Tees CCPP Project

The Tees Combined Cycle Power Plant Project

Implications of Requested Change on the EIA

Figure 1 Viewpoints (VP) Corresponding to Clusters A to D and Scheduled Monuments

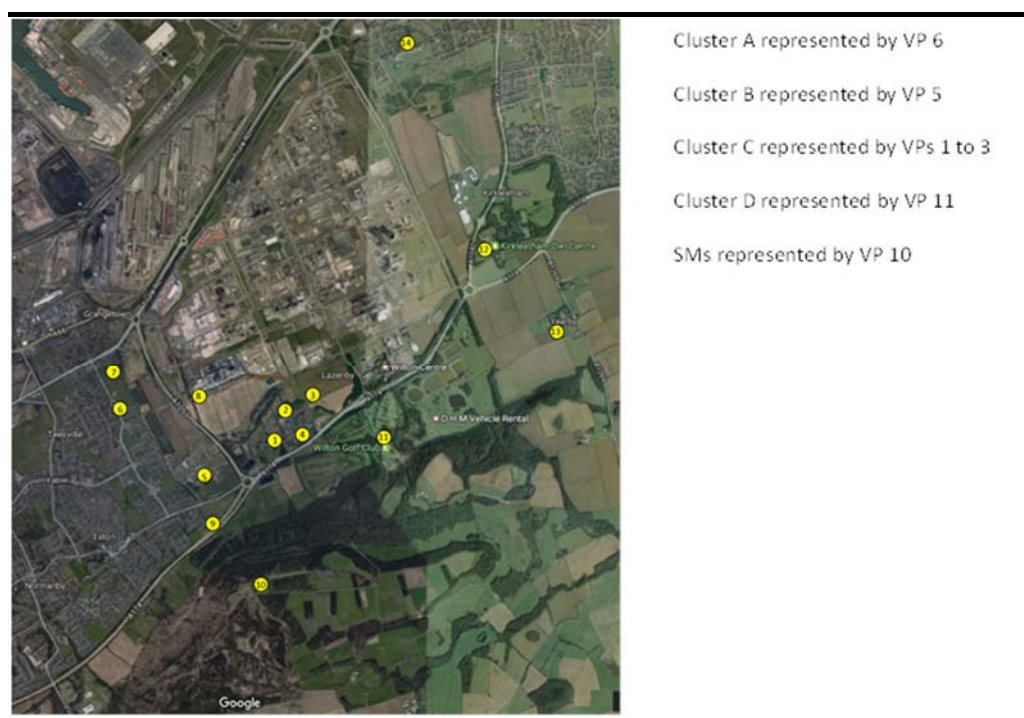
1.22 The designated assets as described in the ES have been grouped into four 'clusters' as shown on Figure 1 below. These clusters are broadly represented by some of the viewpoints ('VP') used in the landscape and visual impact assessment, namely: cluster A represented by VP 6; cluster B represented by VP 5; cluster C represented by VPs 1 to 3; cluster D represented by VP 11; and the two Scheduled Monuments represented by VP 10.

1.23 As can be seen in Table 2.1 earlier in this document, the landscape and visual assessment of the requested change does not alter the magnitude of impact or significance of effects at any viewpoint. This includes for example the viewpoint 10 Eston Nab Scheduled Monument where the requested change will be most visible since the Project will not be screened as in the closer views. However, from this long distance view the Project will be viewed in

1.24 The conclusions within the cultural heritage assessment of the ES are therefore unaffected by the proposed building height alterations.
